FILE: BRMLB-9007-00(014) Fulton **OFFICE:** Engineering Services
P.I. No.: 752015
Courtland Street Bridge Replacement **DATE:** June 16, 2011

SUBJECT: IMPLEMENTATION OF VALUE ENGINEERING STUDY ALTERNATIVES

**RE: Value Engineering Study Alternatives for Courtland Street Bridge Replacement,
BRMLB-9007-00 (014), P.I. No. 752015**

RECOMMENDATION B-2

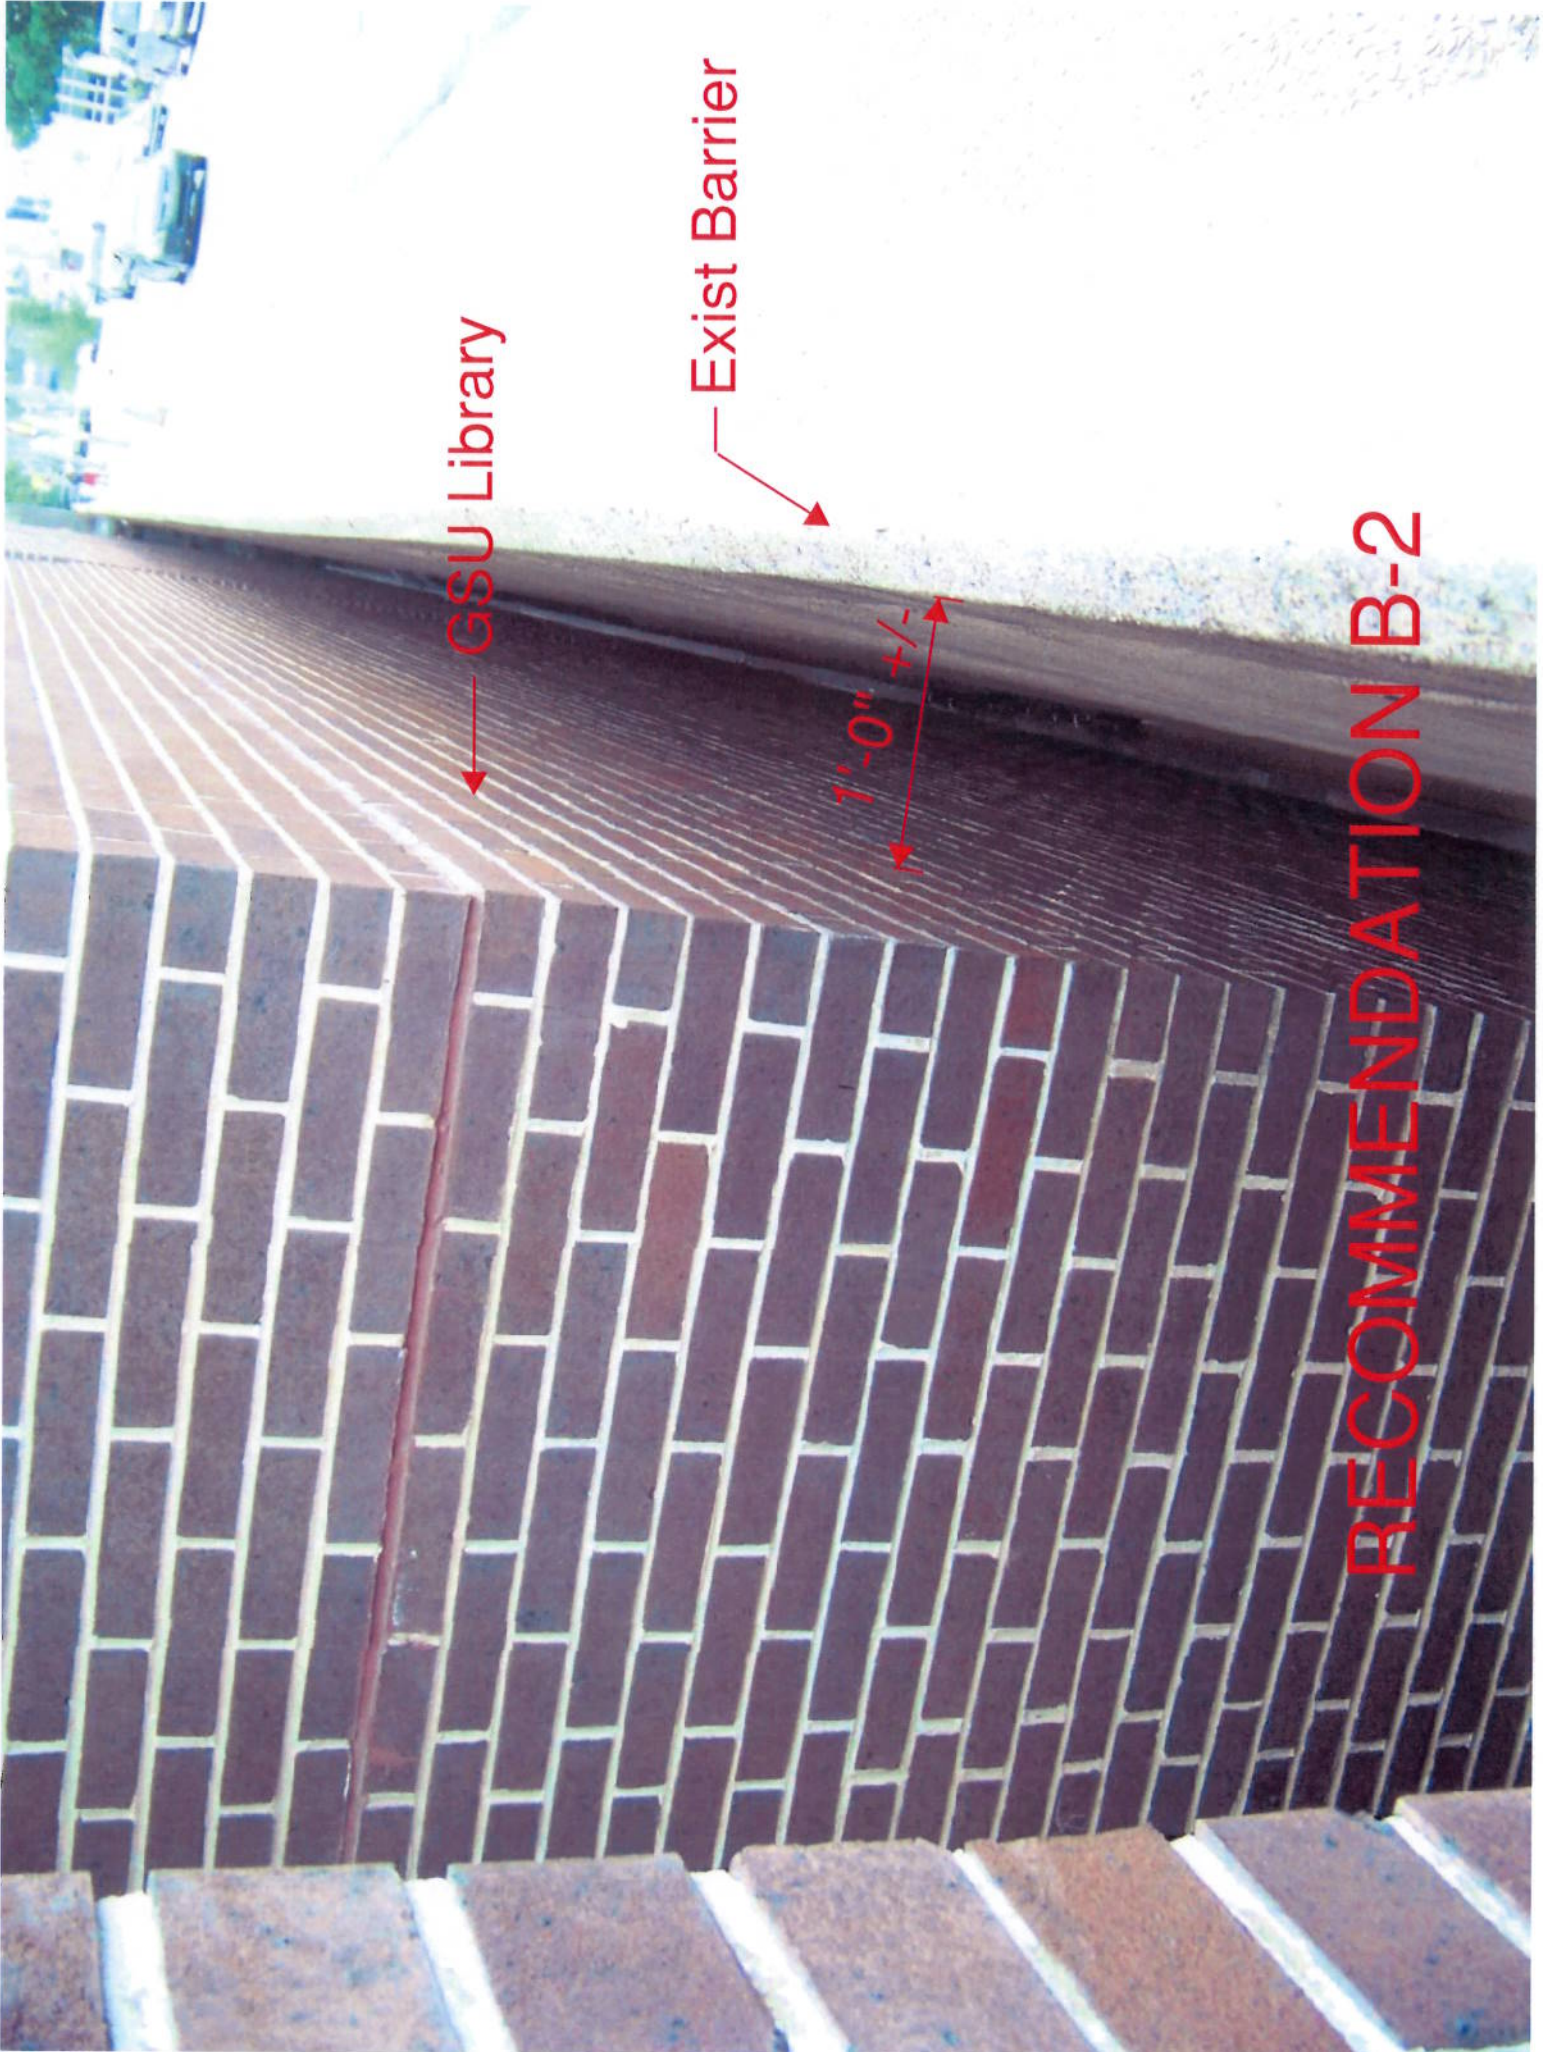
3. Recommendation B-2: Eliminate the bridge parapet alongside the Library North Building.

VE Team Savings: \$32,000.

No, will not implement. The library is located approximately a foot behind the existing back of barrier (see attached photo) with the distance increasing at the windows. The barrier is placed between the sidewalk and library to protect pedestrians from falls while protecting the structure from vehicular impact. In addition, the bridge and sidewalk would need to be widening in that area to reduce the opening thus reducing a significant portion of any potential savings.
